**200 Forest Way, Belrose NSW 2085 – DA2019/0581**

1. I refer to your request from Corona Projects to address TfNSW/RMS comments with regard to the above development proposal (TfNSW letter dated 06/04/20, Ref. SYD20/00301/01).
2. Our response to the TfNSW comments is as follows.
3. Comment:

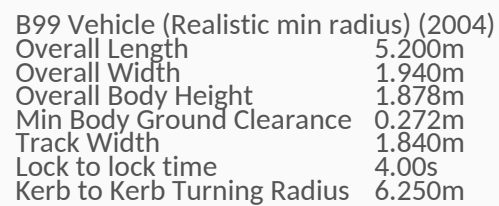
It is noted that there is an alternative access from Linden Avenue, therefore TfNSW would not support access through the property. It is recommended that access through the property is restricted to separate the general public from heavy vehicle deliveries. In addition to the access arrangements along Forest Way being further refined to ensure safe ingress/egress.

Retention of the access from the existing driveway on Lot 1 (DP 1205253) to Forest Way is not supported. Should there be access to Lot 1 from Forest Way through the existing carpark, access through Lot 1 to Linden Avenue would not be supported.

4. Response:
  - a) It is not proposed to have through access, connecting Forest Way with Linden Avenue. The access driveways shown on the plans and in TEF report dated 29 January 2020 are existing access points. The proposal does not seek to create additional access points or connections, on the contrary it includes a proposal to close one of the existing driveways, thus improving the safety situation.

- b) It is proposed to continue to use access from Linden Avenue for deliveries by heavy vehicles, as at present. Additional overflow parking for staff is proposed between the loading/unloading area and the garden nursery. The use of this parking will be managed by the operator of the nursery. To prevent movements of customer vehicles from customer parking (accessed from Forest Way) to Linden Avenue and vice versa, it is proposed to install a gate between the loading/unloading/bulk storage area and the nursery/cafe area, as shown on TEF drawing 19083/01 Rev B attached to this letter.

Dwg No 19083/02 | Rev. B | 28/04/2020  
Client:  
Robert Marci

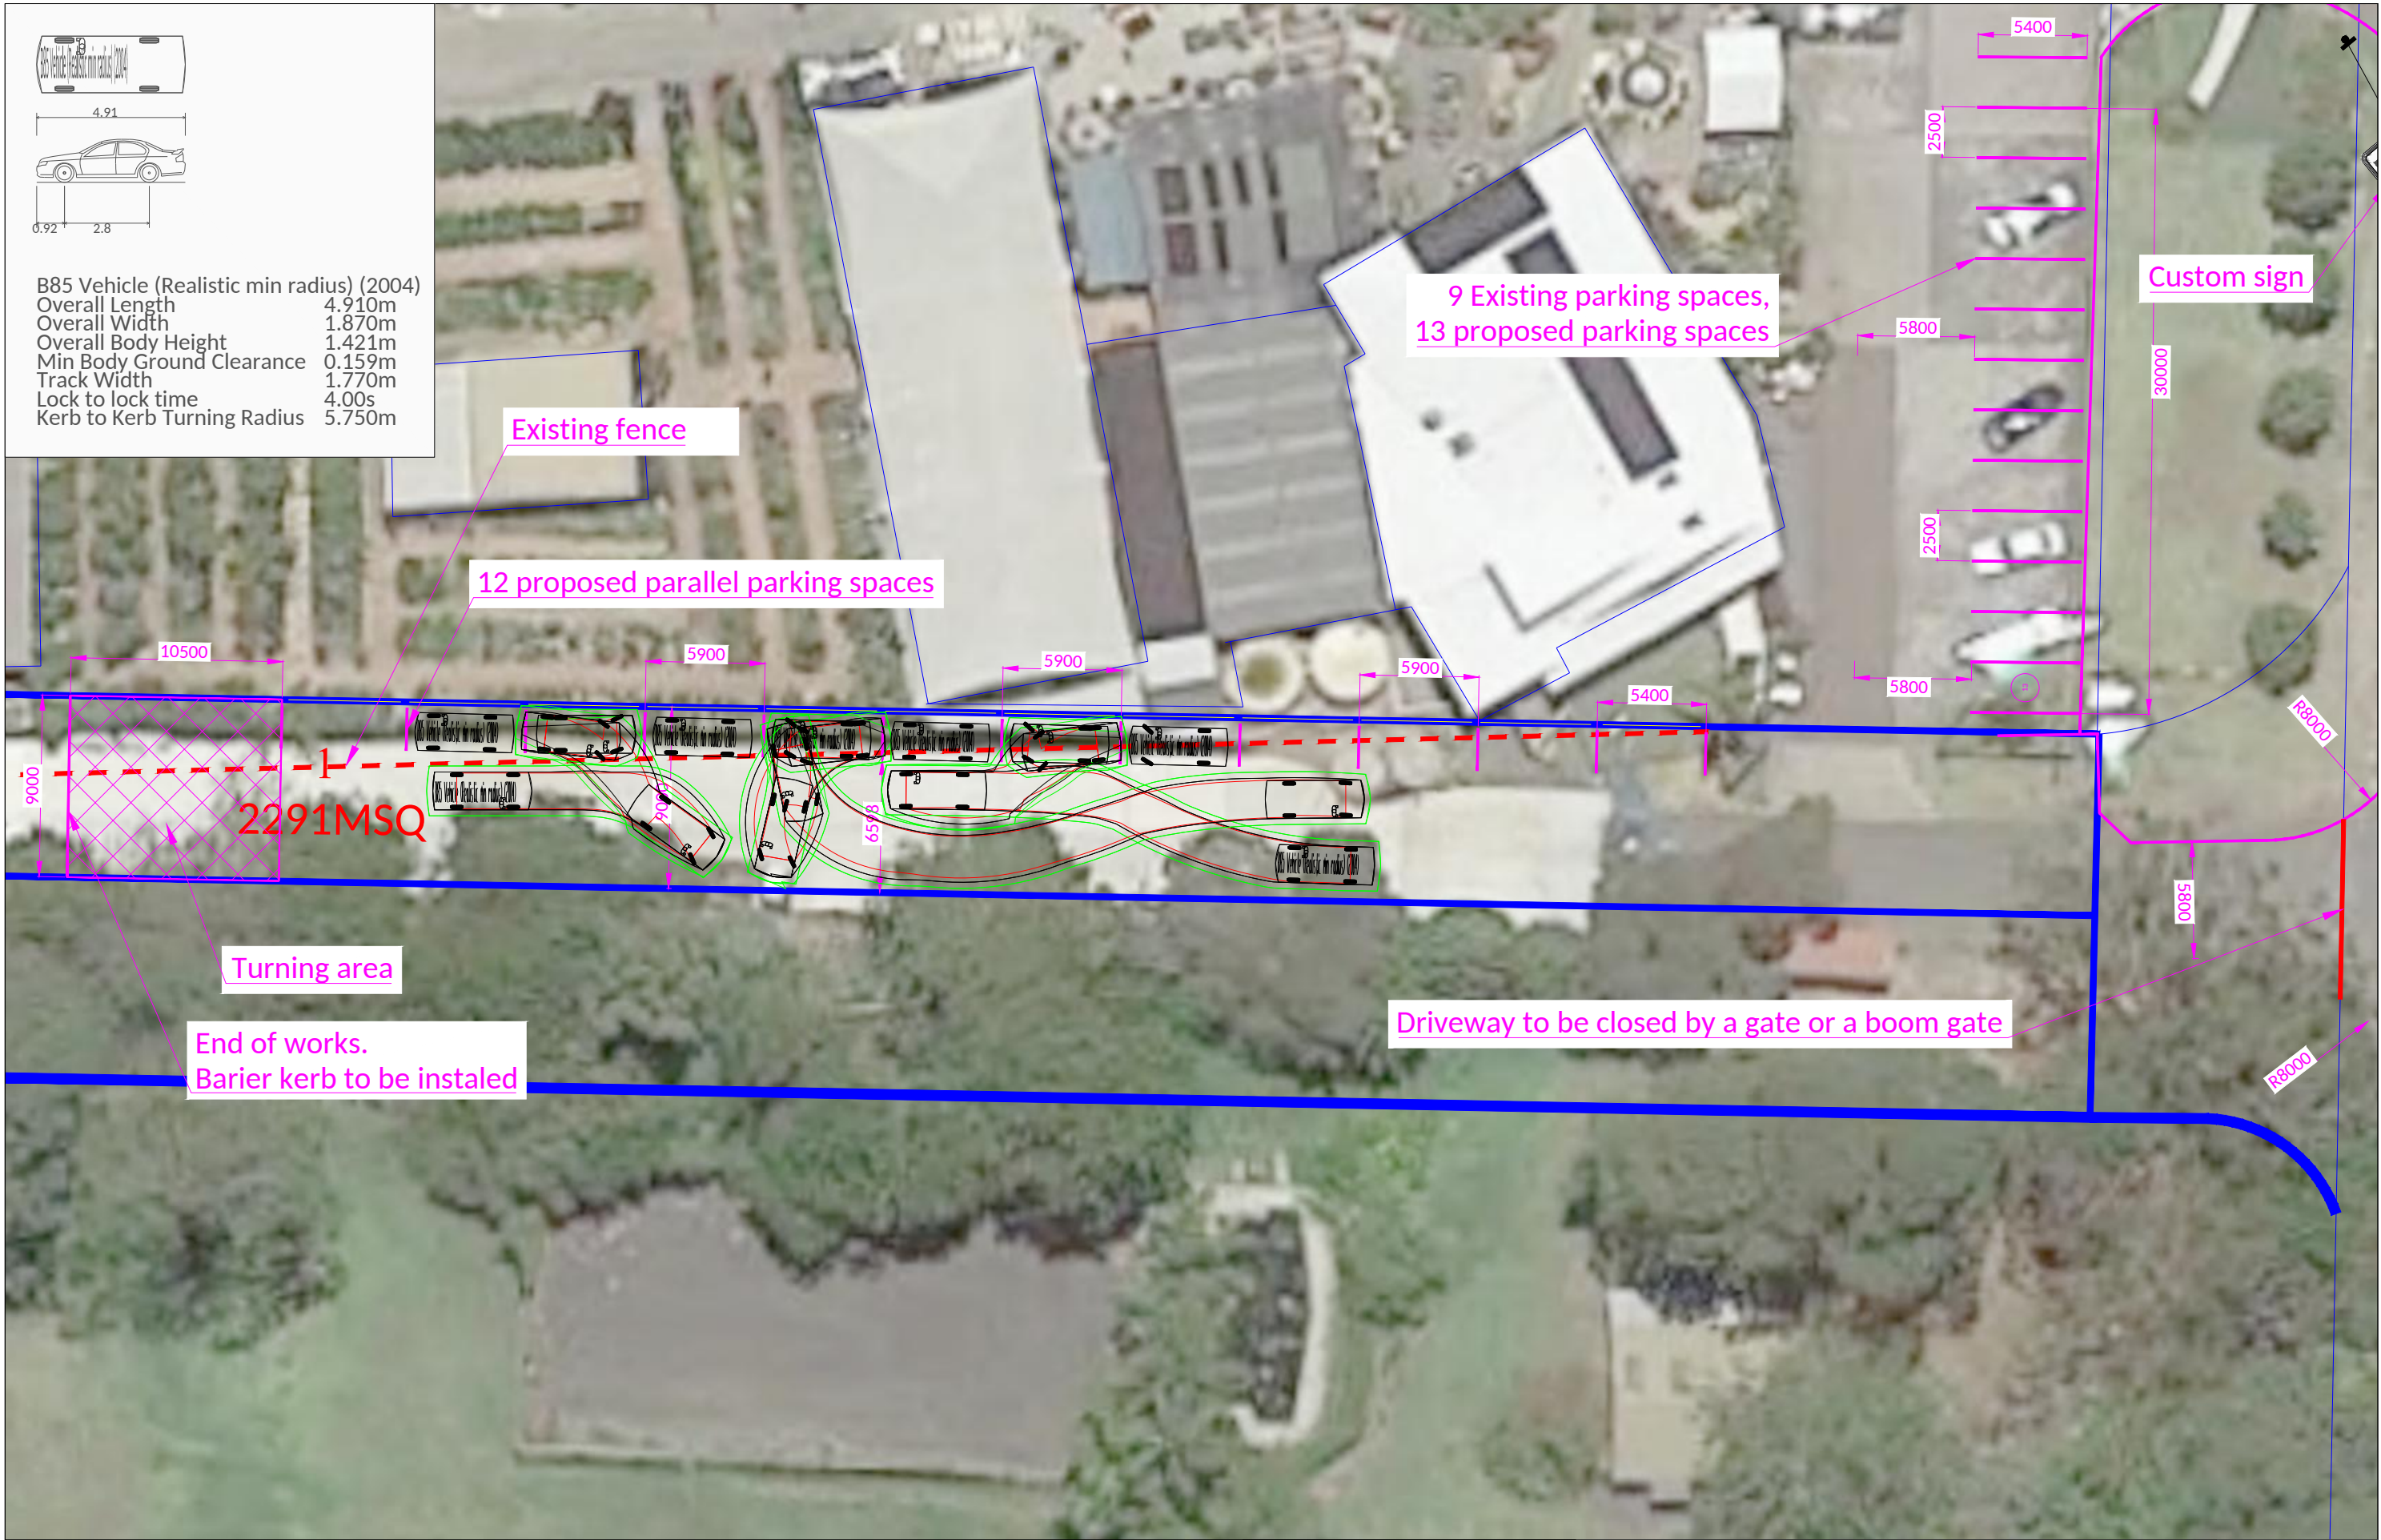
5. Comment:
  2. Proposed 17 x 30 degree angled parking:
    - i. The supplied turn paths show that vehicles are unable to enter/leave the carpark simultaneously.

- ii. There is insufficient room for drivers to reverse out of carparking spaces and drive towards the exit.
    - iii. The proposed turning area is not considered acceptable by TfNSW and is unsafe.

- iv. The proposed parking arrangement may result in vehicles attempting to reverse the entire length of road and is not practical.
6. Response:
  - a) The proposed design of the new car parking area on the southern side of the site has been reconfigured to parallel parking. The parking aisle is of sufficient width (greater than the minimum width required by AS/NZS 2890.1:2004) for manoeuvring in/out of spaces and for conflict free movements in both directions. The redesigned area now has 12 spaces. Of these, the last 5 spaces are proposed to be designated for use by staff. This arrangement will help minimise the number of

For example, the swept path plans shown in the current traffic engineering assessment provided do not indicate vehicle lengths and should be provided as per TfNSW letter dated 5 July 2019.

Furthermore, the turn paths provided on plans numbered DWG No: 19083/01 to DWG No: 19083/03 do not demonstrate how vehicles can ingress and egress simultaneously.

movements in this area. The proposed parallel parking addresses all issues 2 (i) to (iv).

- b) The new arrangement results in a total of 56 car parking spaces on site. This number still exceeds the required 51 spaces and is thus satisfactory.

- a) Drawings Revision B attached to this letter demonstrate the required manoeuvres and vehicle dimensions.

Dwg No 19083/03 Rev. B | 28/04/2020  
Client:  
Robert Marci

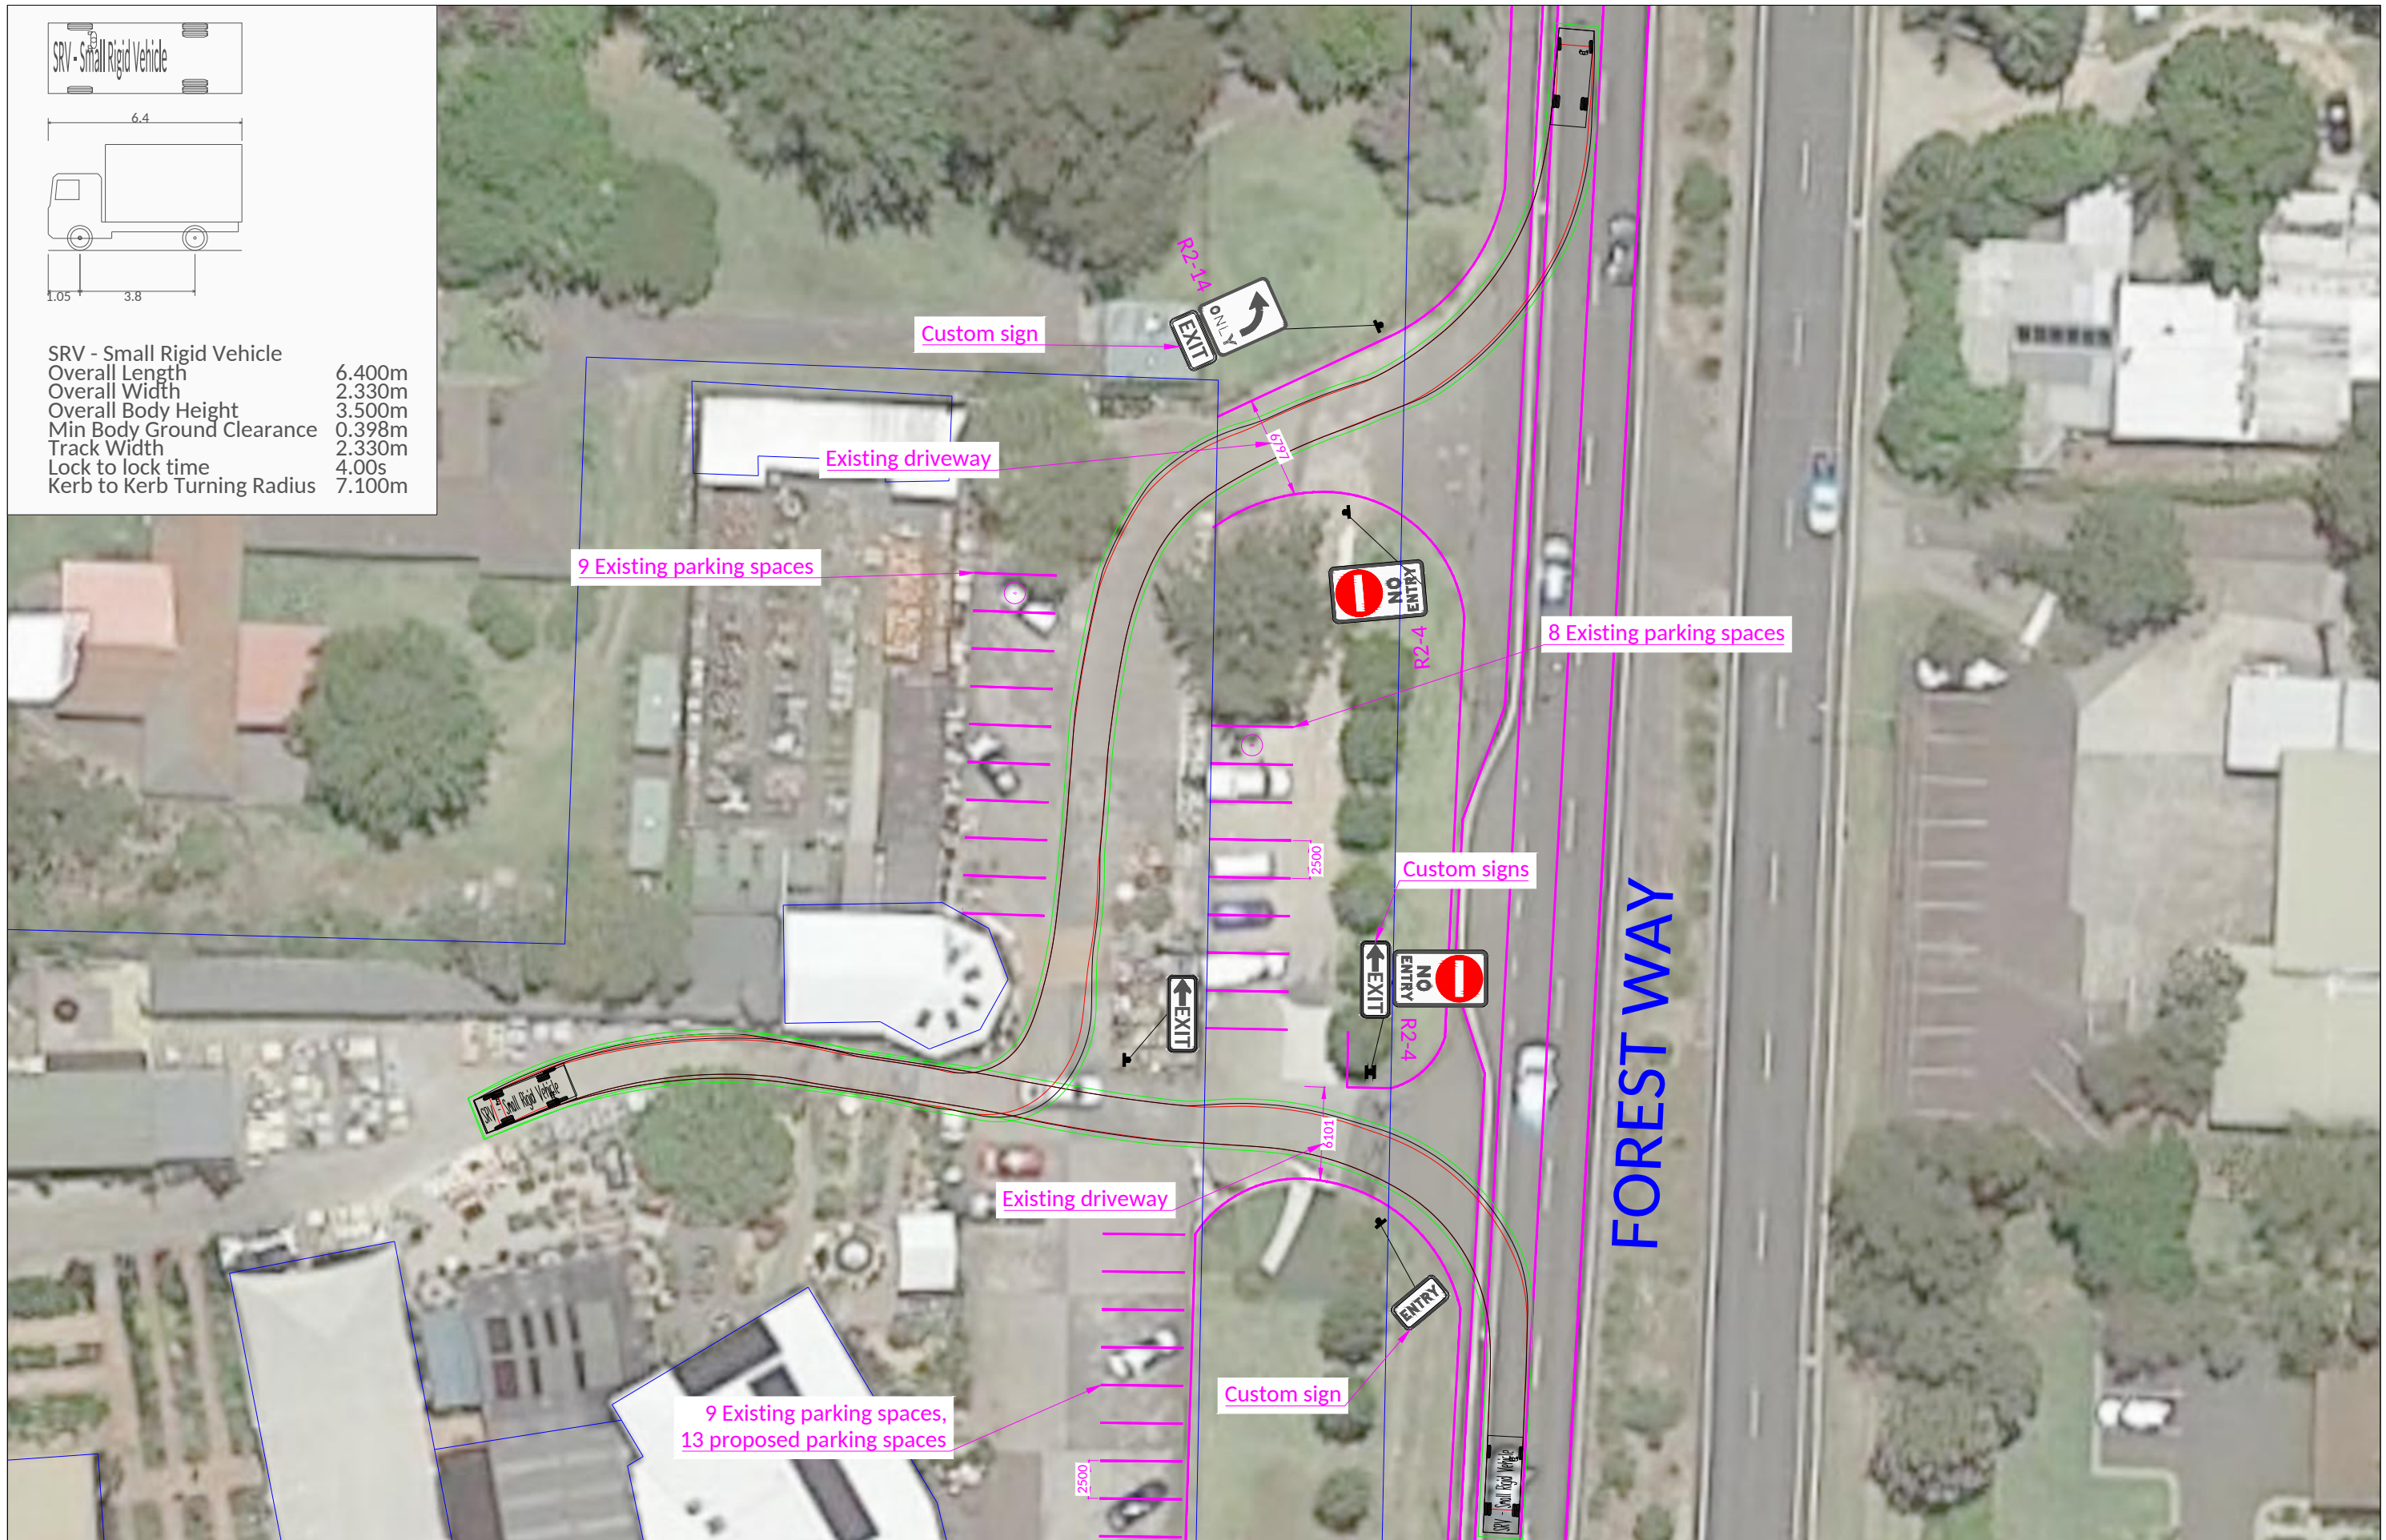
- 4. Updated swept path plans are to be provided indicating how vehicles (including garbage trucks, emergency and heavy rigid vehicles) will simultaneously ingress/egress the subject site via the above mentioned driveways. These plans shall be in accordance with AUSTROADS standards and are to show that vehicles can ingress/egress in a forward direction.

- c) The design has been checked for simultaneous movements of heavy rigid vehicles. Both garbage trucks and emergency vehicles (including standard fire brigade appliances) are smaller and thus will have no difficulty in performing the same manoeuvres.
